Competitor's Valve Cover 11 12 7 552 281

Scope

The OTHER brand Valve Cover 11 12 7 552 281 does not pass APA Quality Inspection.

Figure 2: NG part fit location #1

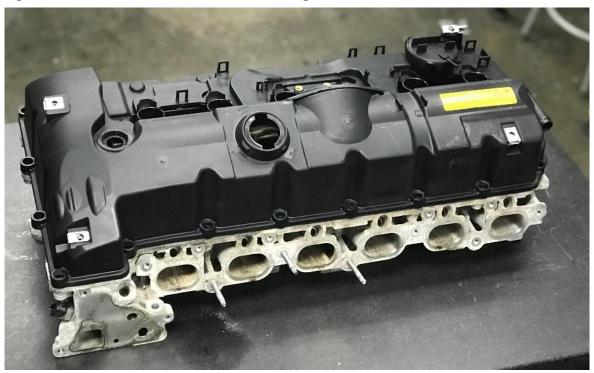
The OTHER valve cover was attempted to be installed on the OE Engine Head Shown in Figure 1. Installation was attempted by 4 other members of the engineering staff with the same result. The OTHER Valve cover does not fit the OE Engine Head properly. The installation attempts revealed 2 bolts that could not achieve proper fit and torque, shown in Figure 2 and Figure 3.

Figure 2a: Electric impact tool achieved specified torque, yet gasket was not compressed due to sleeve stand off.

Figure 2c: Female fastener sleeve could not accommodate male locating feature.

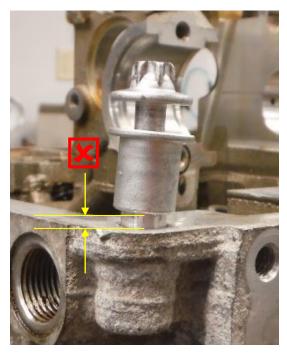
Figure 2b: Locating feature on engine head has larger OD than fastener sleeve ID.

Figure 2d: Valve cover without bolt or sleeve. Housing must be forcibly deformed by installer to align fastener holes.

Figure 3: NG Part Fit Location #2

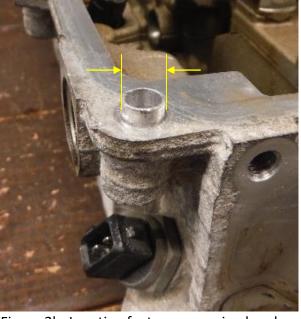
Figure 3a: NG Part Fit Detail: bolt did not achieve specified torque due to part dimensions.

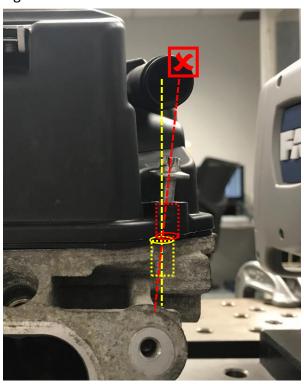
Valve Cover hole location creates a NG bolt angle (in red), which did not allow the fastener to be installed to proper torque.

Figure 4: CMM DATA: FARO ARM

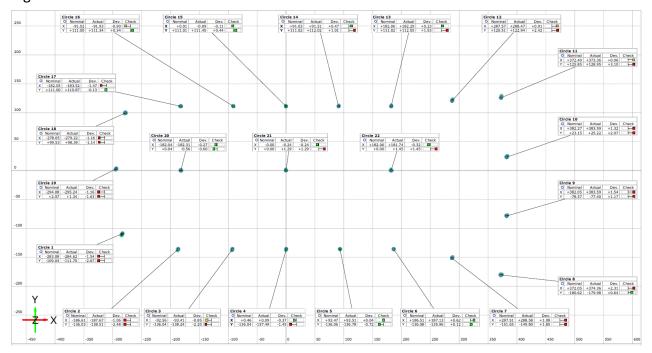
The press-fit fasteners were removed and the hole locations were measured using the FARO Arm, and then related to the corresponding location on the Engine Head.

Applying a positional tolerance on each point of \pm 1.0mm, the OTHER valve cover has 17 out of 22 holes with a NG hole position in either the x-direction, y-direction, or both.

Additionally, the holes on the left side of the image, holes 18, 19 and 1, are off location in the X negative direction. The holes on the right side of the image, holes 11, 10, 9 and 8, are off position in the X positive direction. This is an additive situation. If you install a bolt into one end of the valve cover, all of the error is pushed to the other end of the part, causing the NG install experienced during the part fit activity.

Figure 5: Fasteners Falling Out

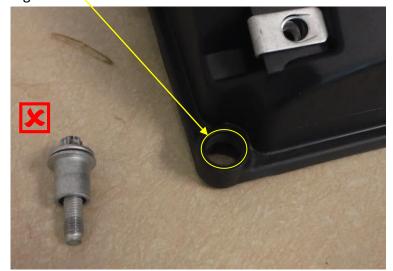
Upon unboxing, the fasteners shown in Figure 5 fell out of the valve cover assembly with little or no outside influence. This is not acceptable for customers. The cover molding must have a proper press-fit/interference fit between the valve cover main body and the fasteners.

Figure 6: NG Appearance - Tooling Marks

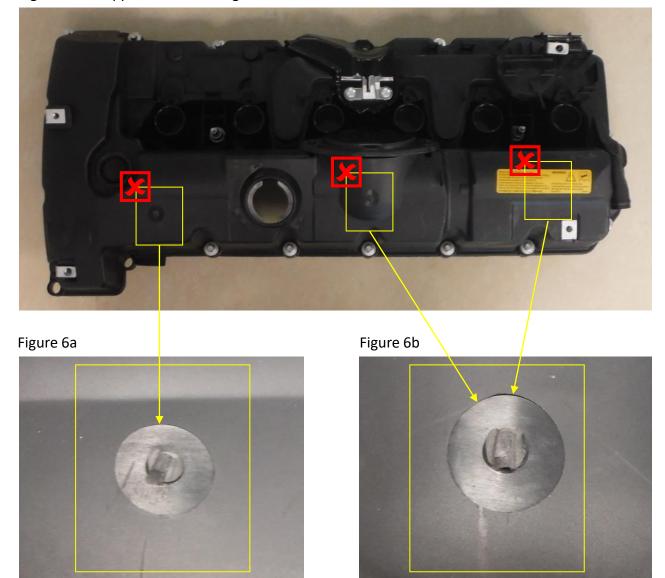
The main molding of the valve cover has rough tooling marks from the injection molding process. These marks are located on the top of the part, where they are visible in the engine bay of the automobile. This is an NG appearance for the customer.
